# Administrative Approval Action

Case File / Name: SUB-0034-2023  
DSLC - Yardly Buffaloe Village

**REQUEST:** The project is requesting approval of a subdivision to create seven Open Lots which will eventually be developed with a total of 222 dwelling units as well as a public and private street system.

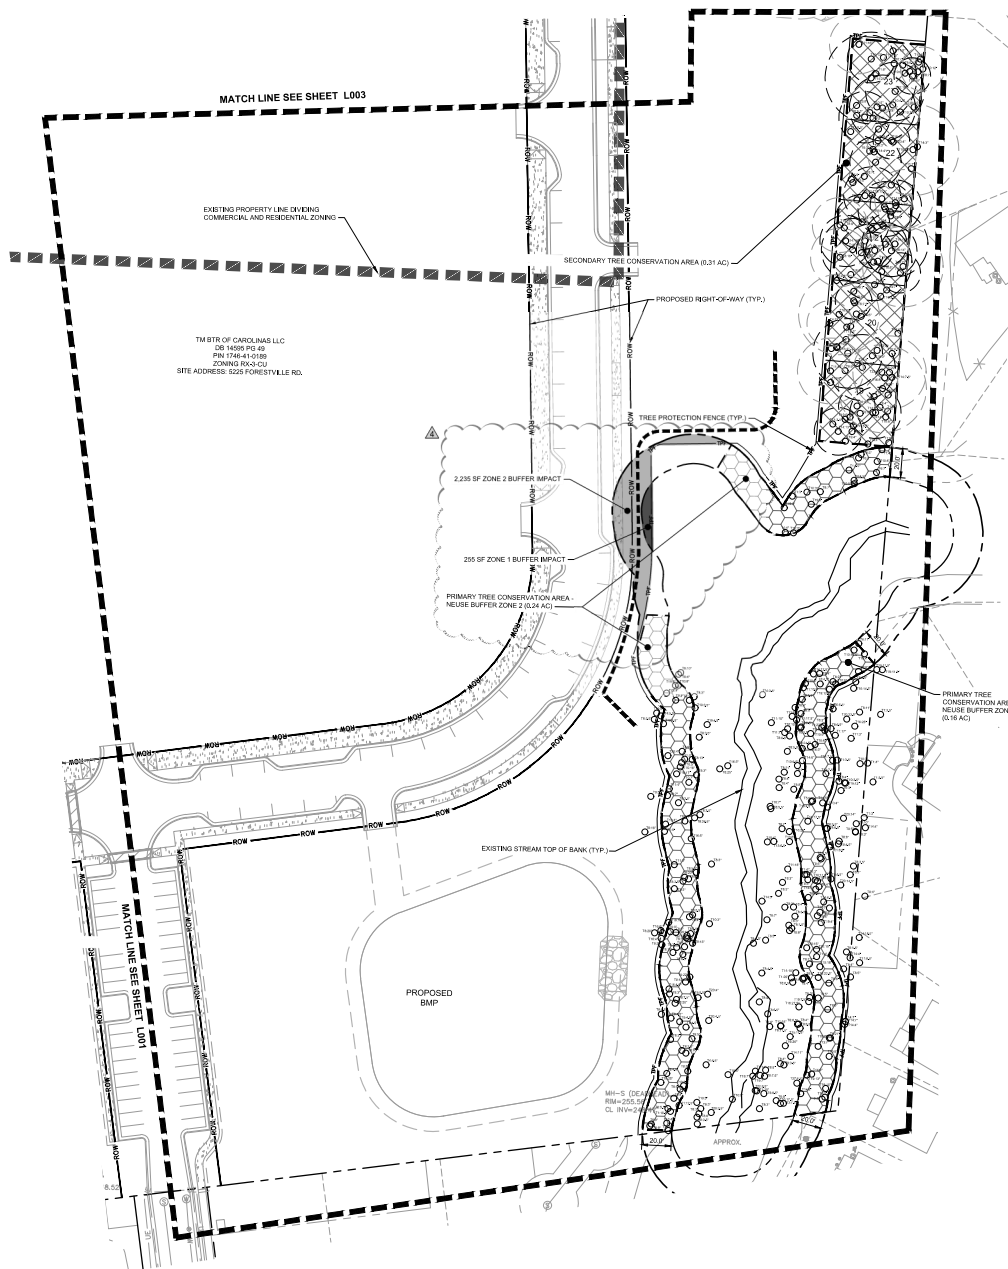
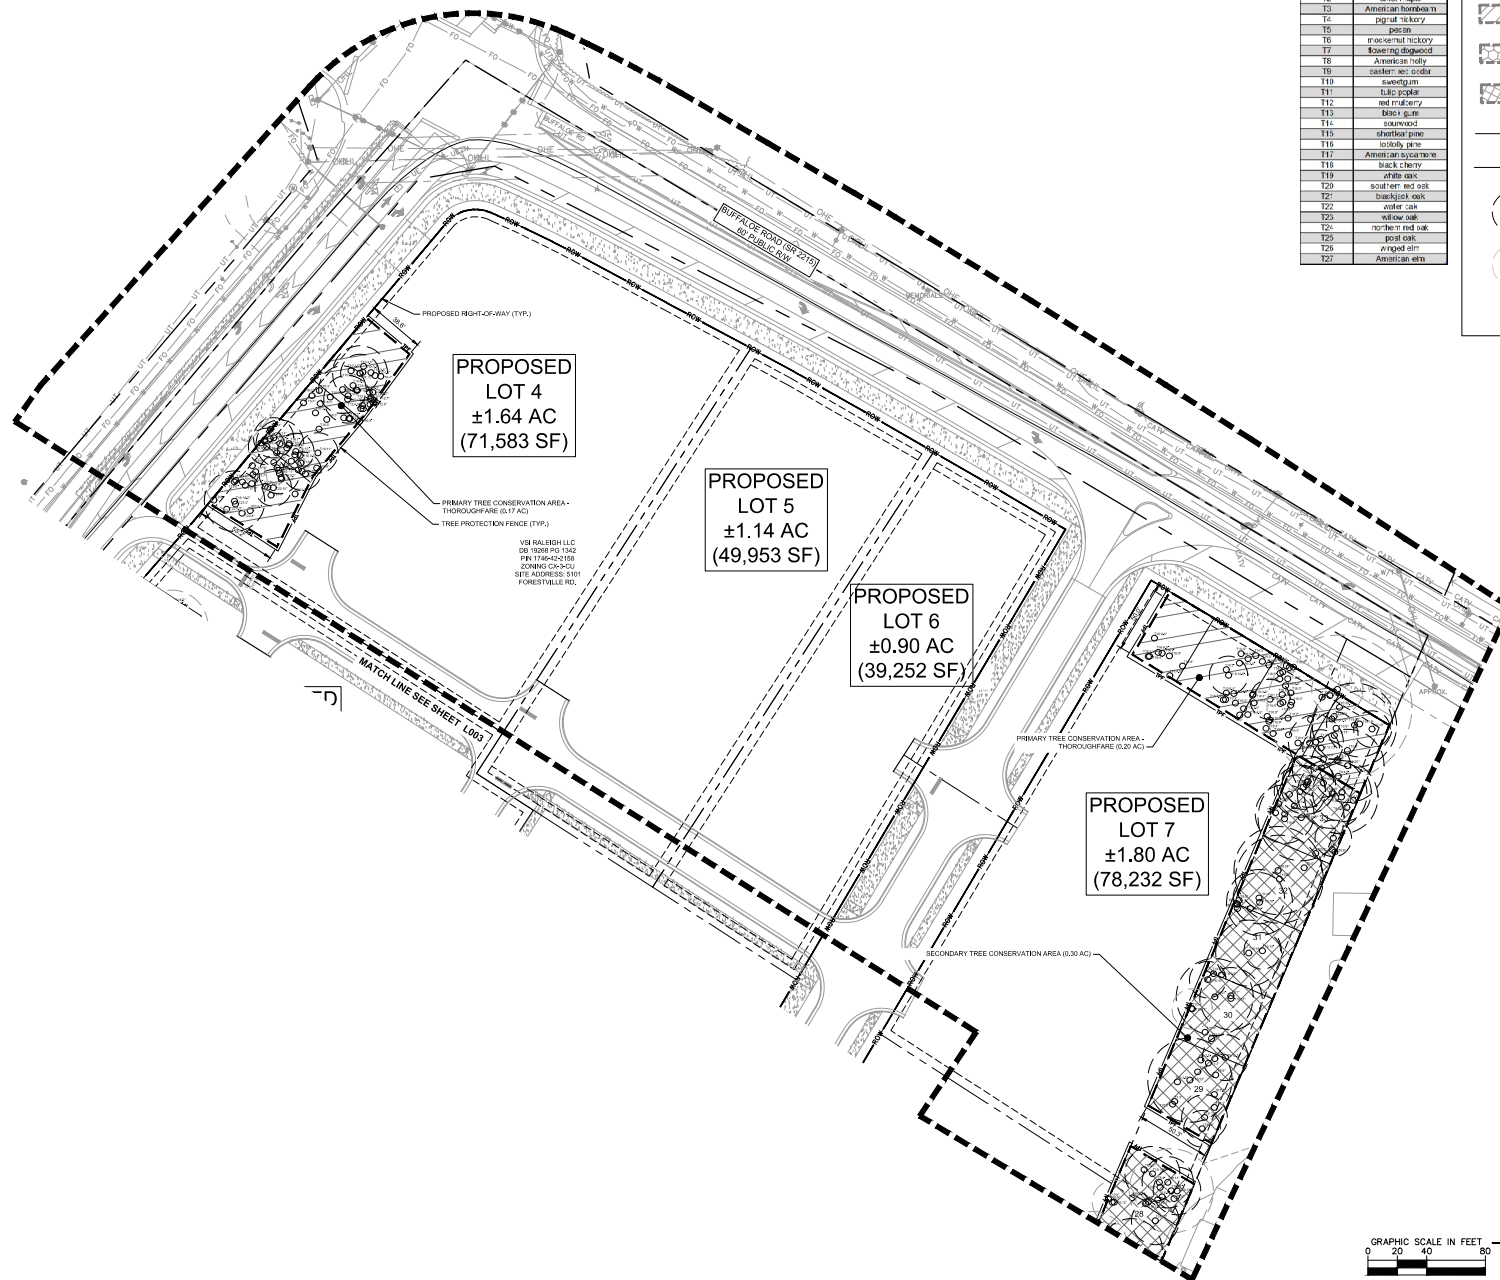
1. A segment of Primary Tree Conservation Area - Neuse Buffer Zone 2 (0.24 acres) narrows to a width less than 20' which is impermissible per UDO 9.1.4.D.1. Prior to SPR, remove the portion of Primary Tree Conservation Area - Neuse Buffer Zone 2 (0.24 acres) that is less than 20' wide, adjust the acreage provided in the standardized label, and update the Tree Conservation Plan Data Sheet.
